What do Cays residents want in Cays Park?

KEY FINDINGS from the 2021 & 2023 Surveys

Kevin Reilly
11/1/2023

PROPOSED PLAN OVERVIEW

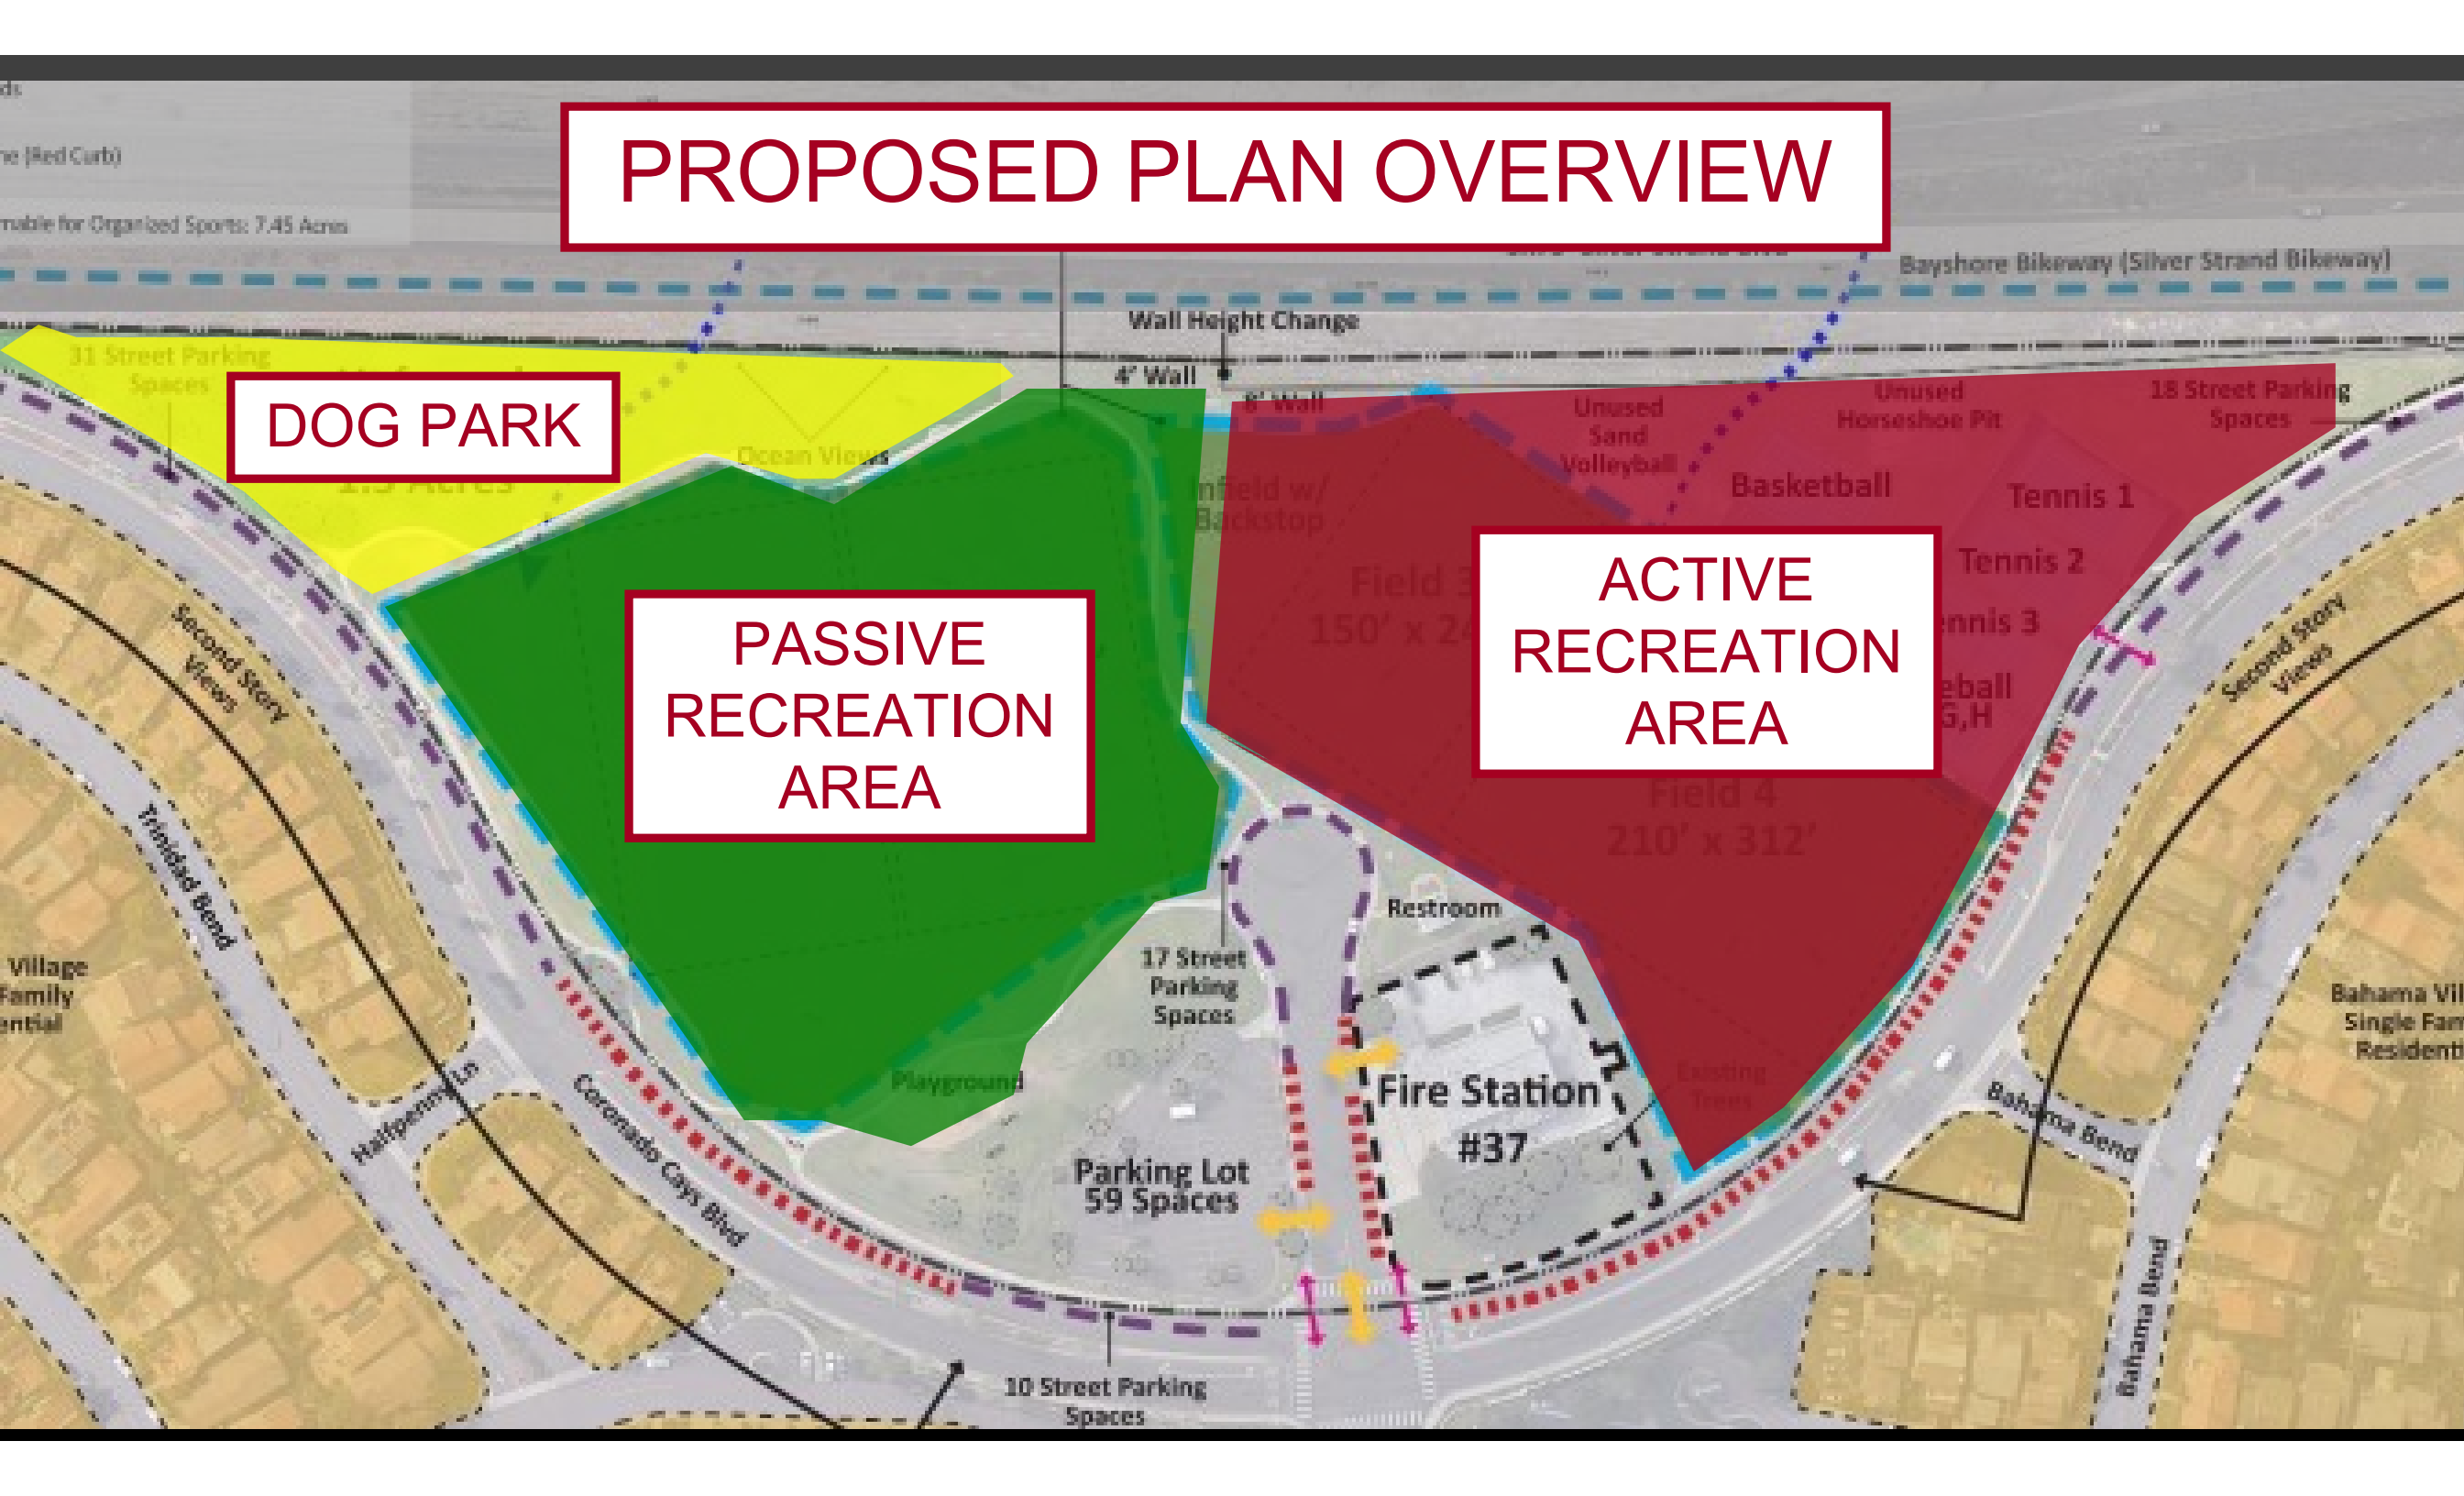
The dog park should be left just as it is with the addition of a low barrier of some kind.
